re: Grading Plan Review
Proposed Apartment Building
3080 Navan Road – Ottawa, Ontario

file: PG6527-MEMO.01

Grading Plan Review

- Grading Plan – 3080 Navan Road (Rhythm Apartments), City of Ottawa – Project No. 122180 – Drawing No. 122180-GR, dated March 20, 2023.

PG6527-FIGURE 1 - 3080 NAVAN ROAD, OTTAWA LIGHTWEIGHT FILL (LWF) RECOMMENDATIONS

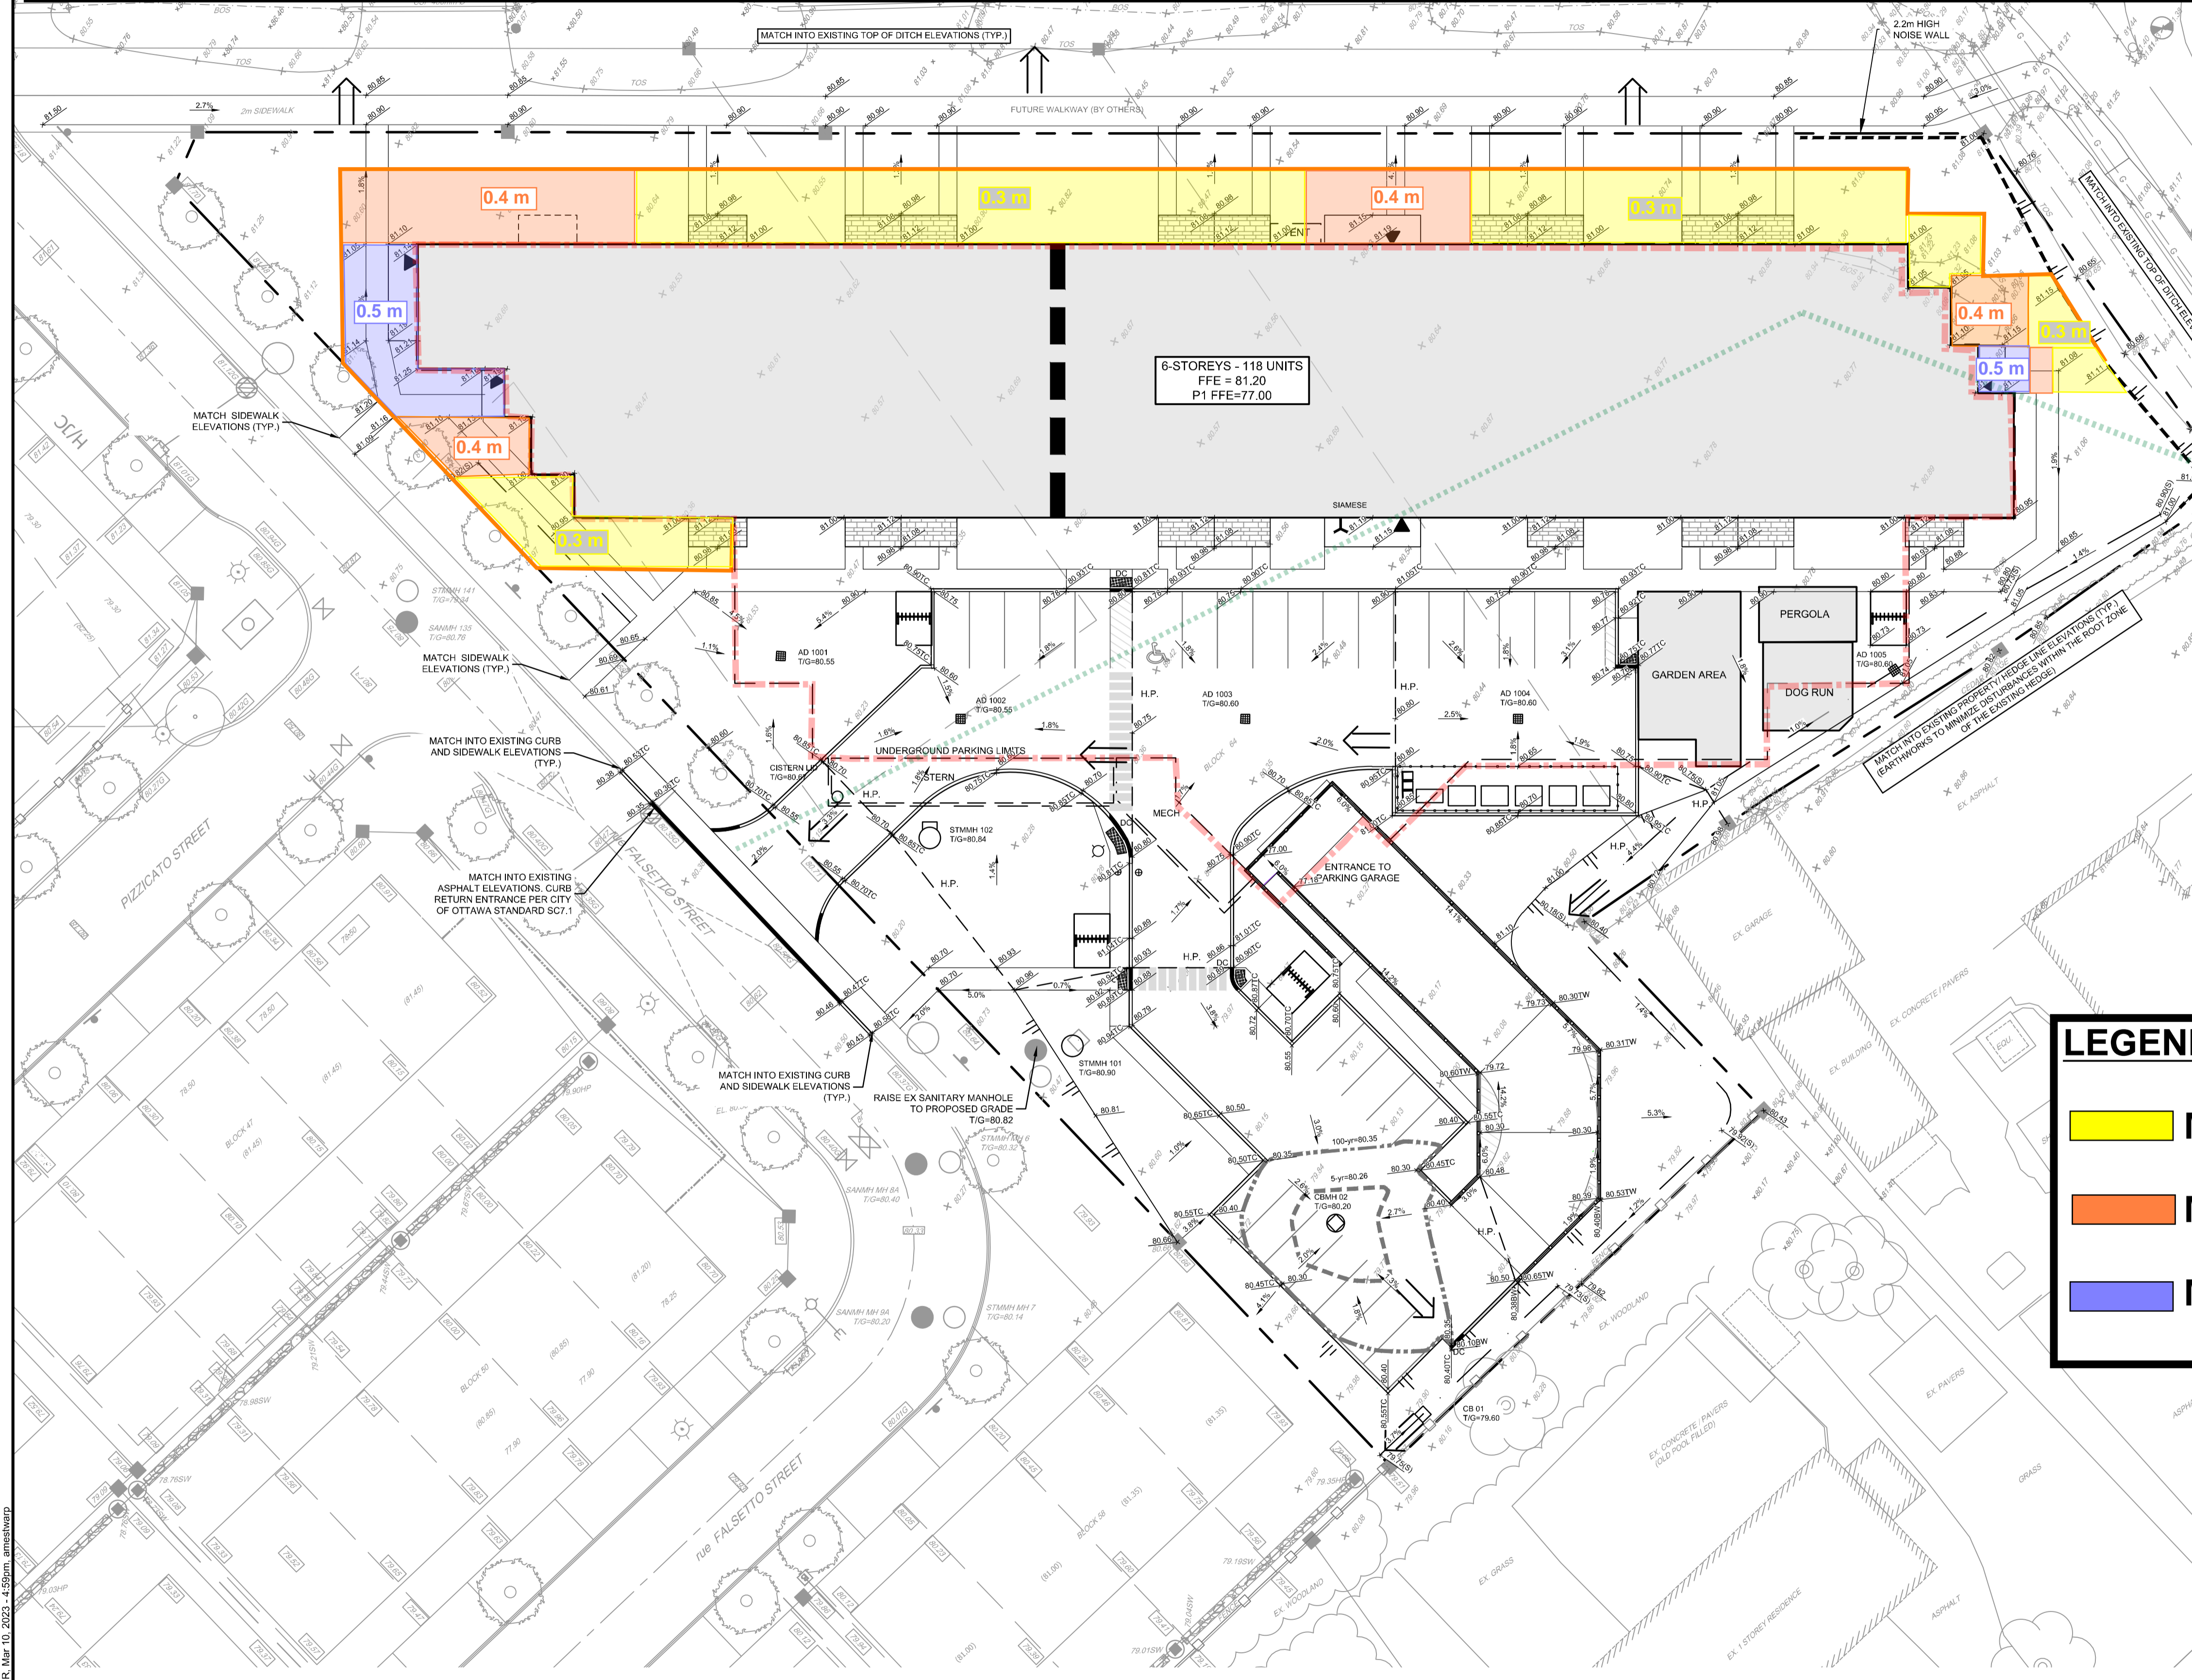
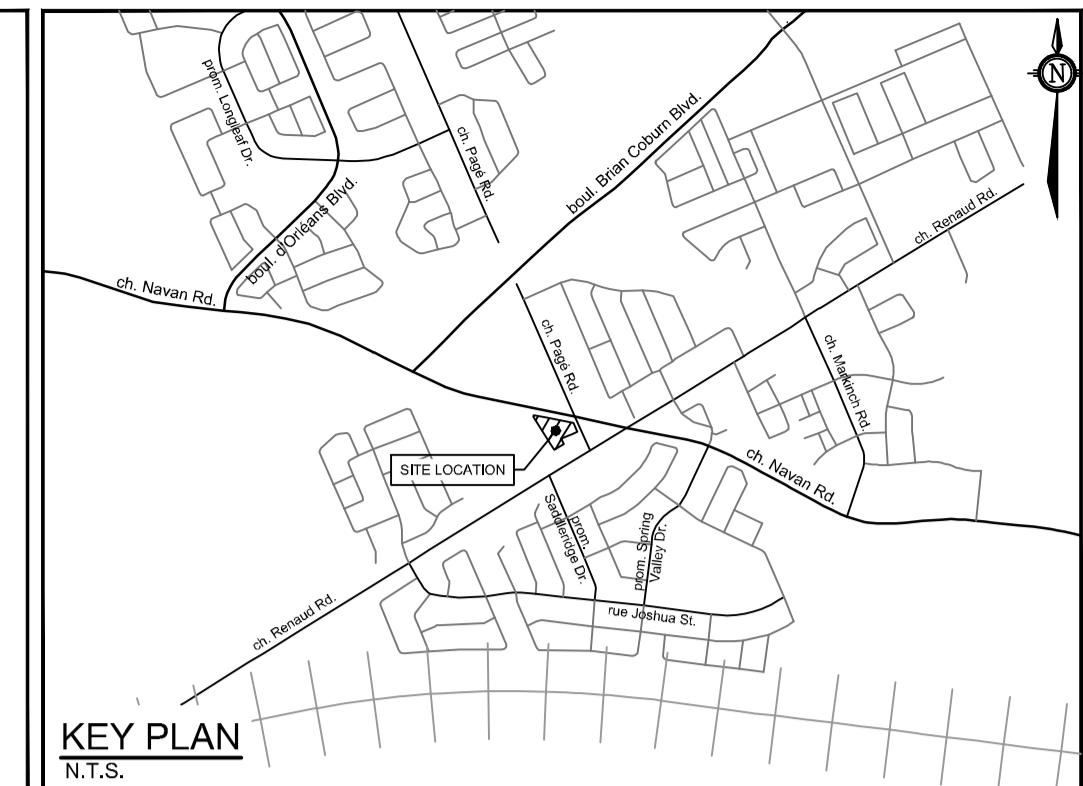
However, in the north corner of the site, grade raise exceedances of up to approximately 0.5 m are currently proposed for the landscaped and hardscaped areas located within 5m of the building footprint. Where these grade raise exceedances are proposed, lightweight fill (LWF) is recommended to mitigate excessive settlement. The attached figure PG6527-Figure 1 – Lightweight Fill Recommendations indicates the approximate LWF locations and thicknesses which are recommended.

The LWF should consist of EPS (expanded polystyrene) geofoam blocks, which allow for raising the grade without adding a significant load to the underlying soils. For this application, EPS Type 15 should be used. It should also be noted that EPS is difficult to use under the groundwater level, as it is buoyant, and it must be protected against potential hydrocarbon spills.

As an alternative to the use of LWF, the areas of the proposed grade raise exceedances could be preloaded to the finished grade, or surcharged, using fill materials. This option, however, would require allowing an extensive period of time for the settlement to occur prior to construction, which may not be compatible with construction timelines. Additional information can be provided if this option is being given consideration.
